64-Acre Tract Intermodal Transit Center

FINAL Environmental Impact Report
FINAL Environmental Impact Statement
FINAL Environmental Impact Statement

Placer County, California
August 2000

[1983 BUREC/USFS FINAL EIS]
TENTATIVE FOREST SERVICE DEVELOPMENT PLAN

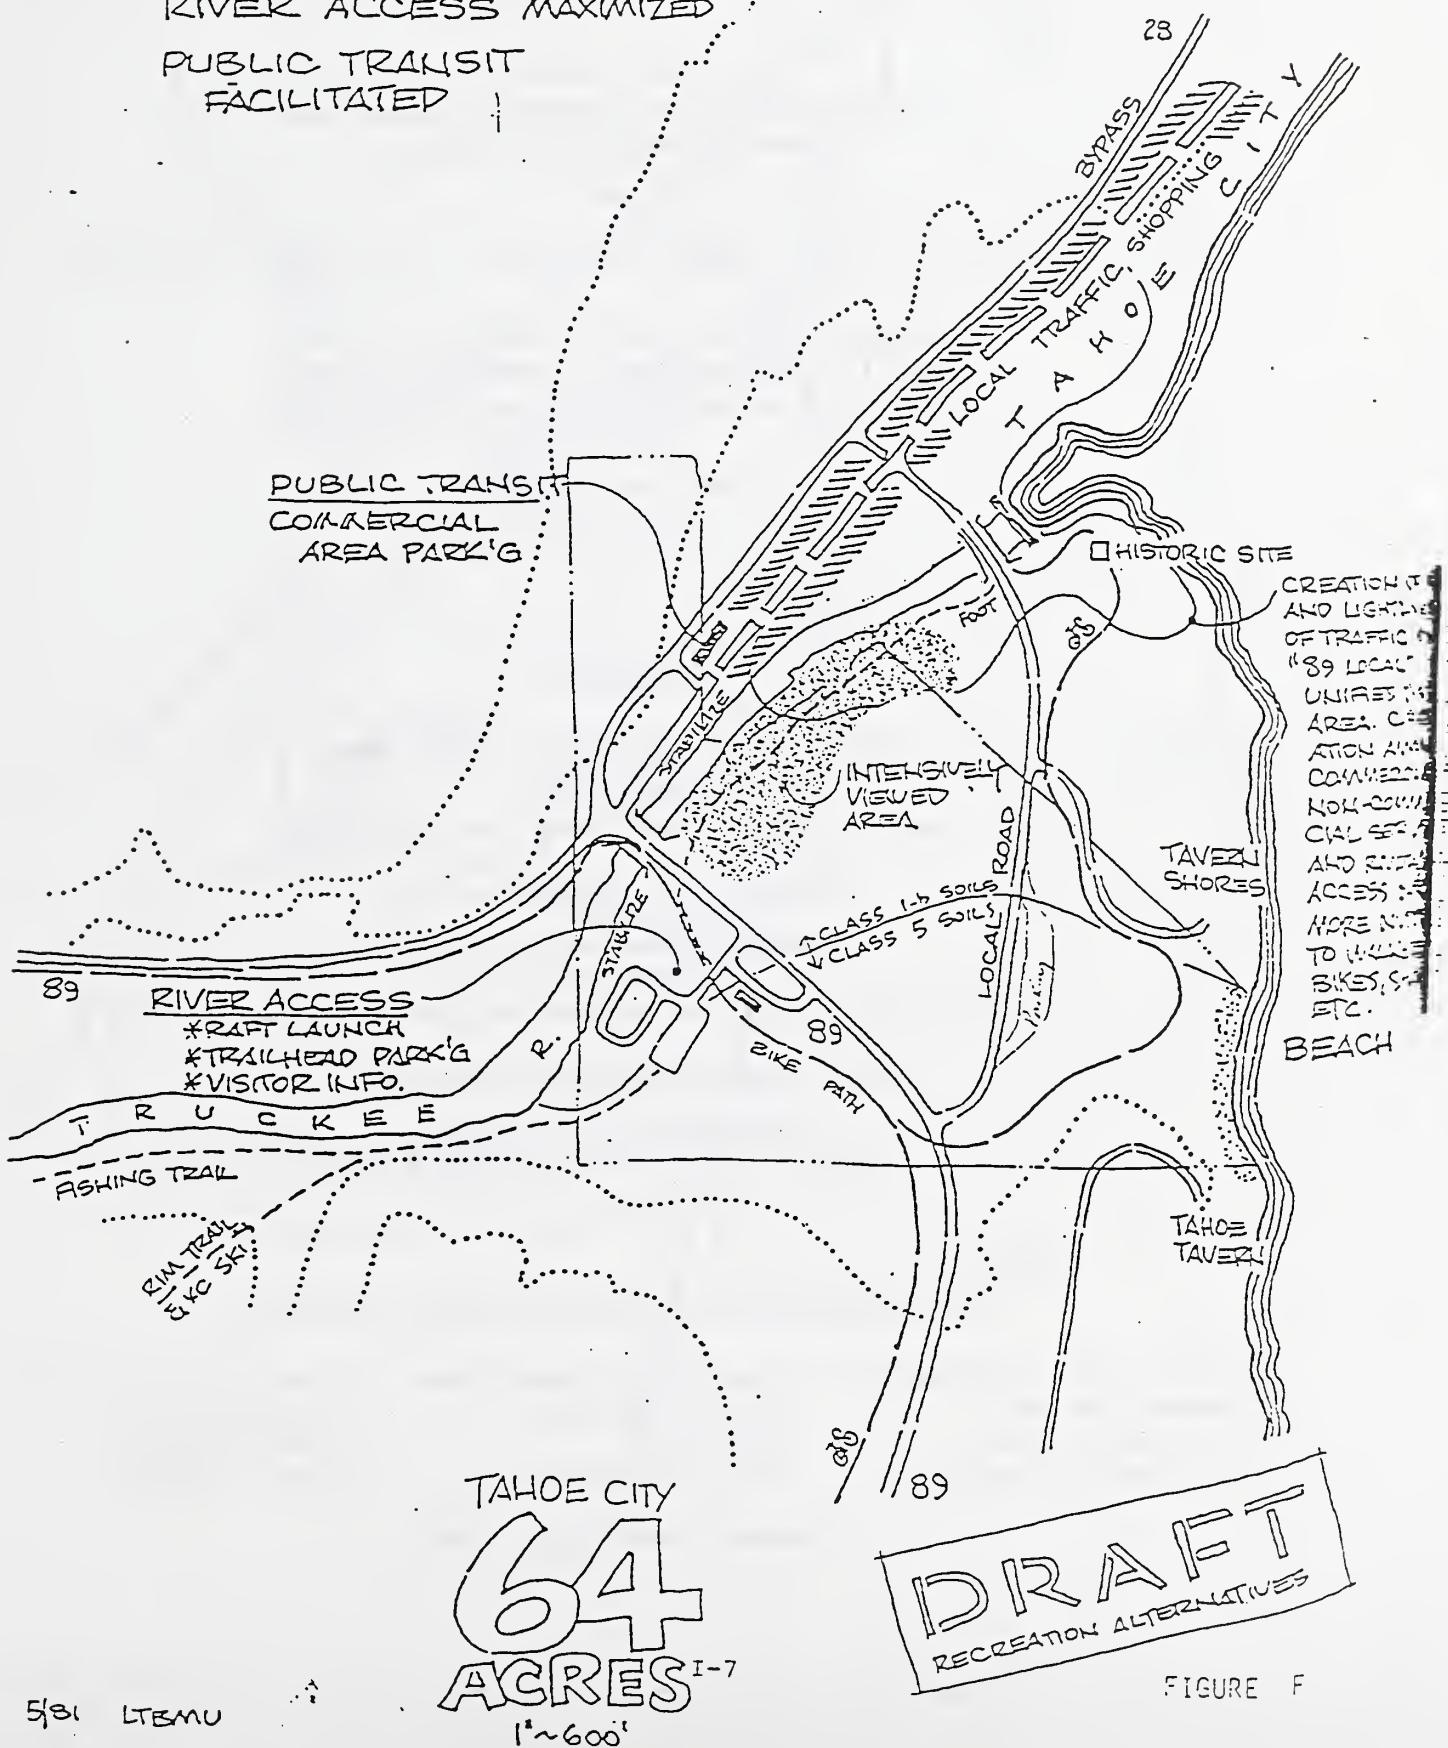
At that hearing we examined for the first time the actual Forest Service development plan for the 64 Acre Tract as contemplated when the Forest Service took title to this land in 1984. That plan appeared at Figure F of the 1983 Final EIS number FES 83-45 prepared by the U.S. Bureau of Reclamation in cooperation with the U.S. Forest Service. A copy of Figure F is attached to this letter. Also attached to this letter is a copy of page 1-3 of the currently-circulating draft EIS, showing the current Forest Service proposal.

FIGURE 6-2. Year 2001 Background Free-Flow Peak-Hour Traffic Volumes

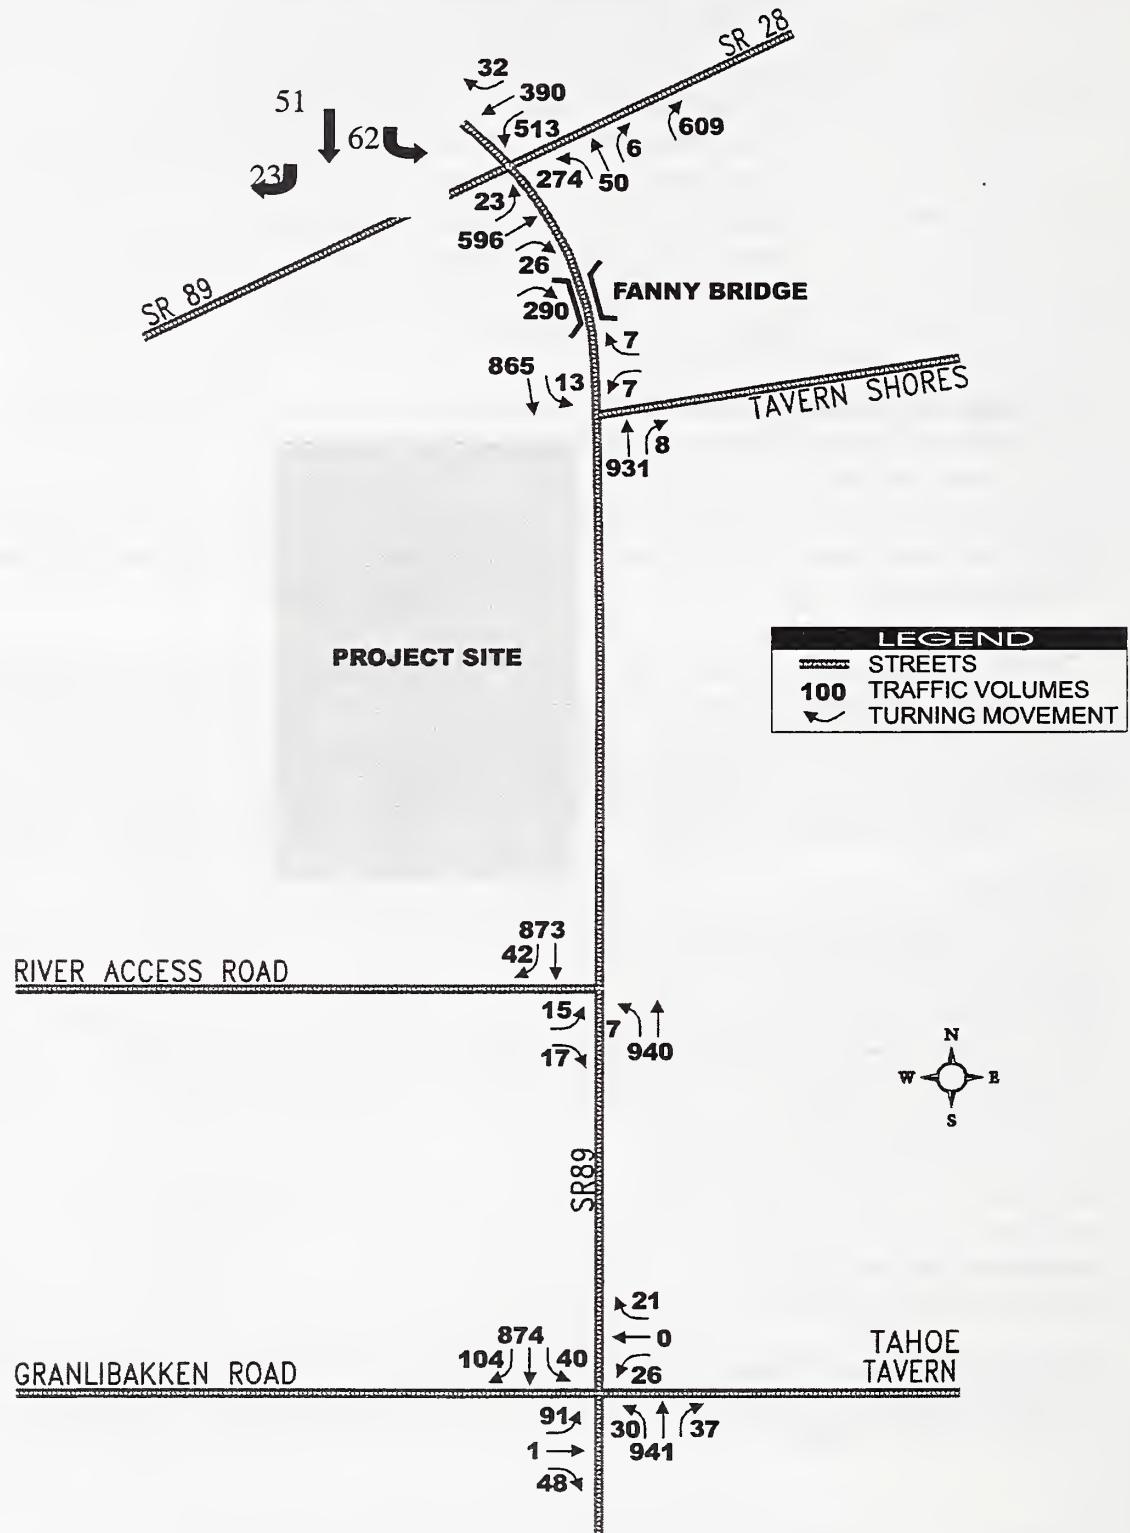
This was an error on that page. The revised values are 23 for the westbound right turn, 51 for southbound and 62 for the eastbound left turn. A revised figure 6-2 is included in the Final EIR/EIS/EIS.

*The following graphic change is added to the Figure 6-2 to represent the vehicle counts and turn movements from the north of the SR 28 and SR 89 intersection which were inadvertently left off:*
